HISTORIC LANDMARK COMMISSION
APPLICATION FOR A CERTIFICATE OF APPROPRIATENESS
JANUARY 11, 2023
HR-2022-170074
CASTLE HILL HISTORIC DISTRICT
613 BLANCO STREET

Construct an addition, carport, pool, and deck to a contributing house.

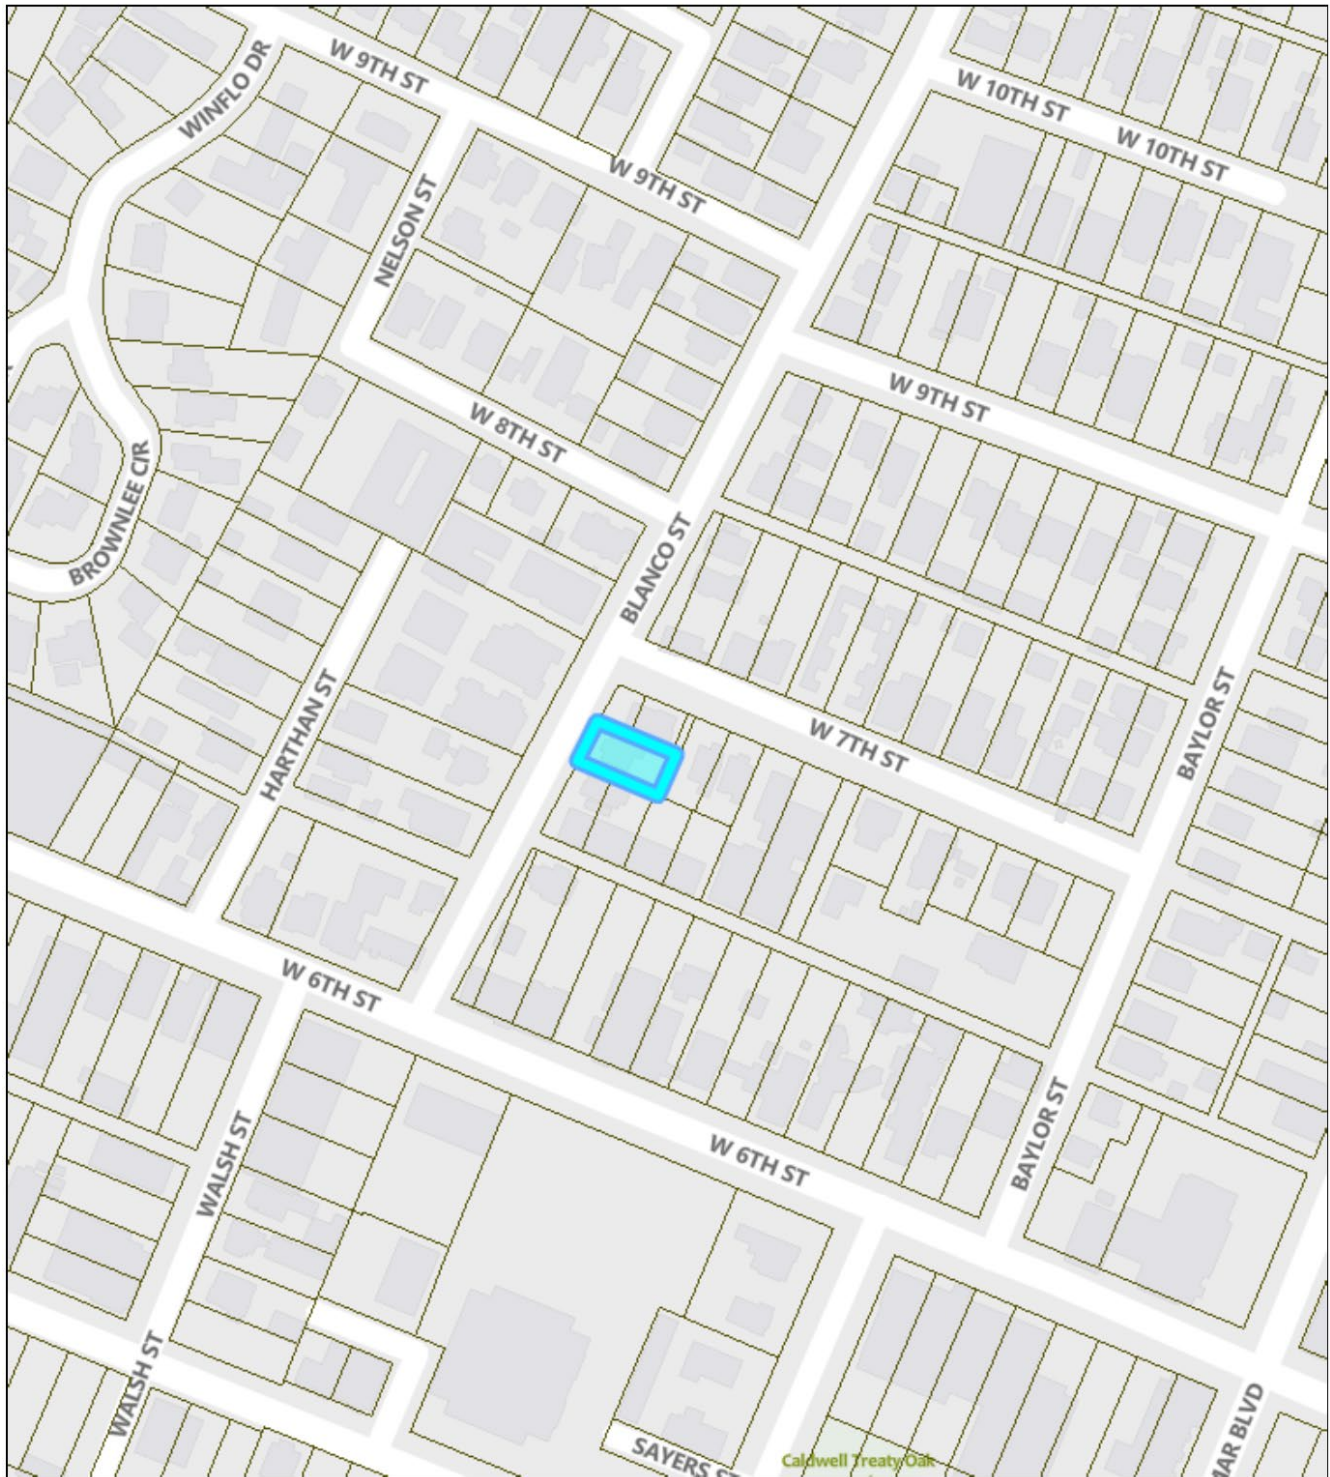
The proposed addition and carport do not appear to destroy character-defining features, though the height of the addition and the dramatic roof forms and fenestration may visually overpower the existing one-story structure.

The proposed project appears to be set back approximately 17', immediately behind the existing ridgeline.

The proposed horizontal cedar siding appears compatible with and differentiated from the existing horizontal wood siding.

The proposed new roof forms do not match the pitch on the existing house.

The proposed windows at the main elevation do not appear compatible.

Rework roof pitch and fenestration to better complement the existing contributing building, reducing the visual impact and verticality of the addition. Consider modifications to front dormer.
